Product Change Notification

Product Change Notification: PCN-22-153957 PCN Date: 27-SEP-22

A91-Circular Commercial Connectors-HDP BKSHL -24SZ,BLK,ST/RA,NW17/19/26,L017 -18SZ,BLK,ST/RA,NW13/17/19,L017

2428-011-2405 REV A2

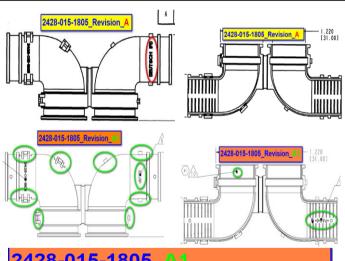
- 1) Latches are having undercuts.
- 2) Material Marking location has changed.
- 3) Deutsche Logo is replaced by TE Logo.
- 4) Cavity Marking (X) added.
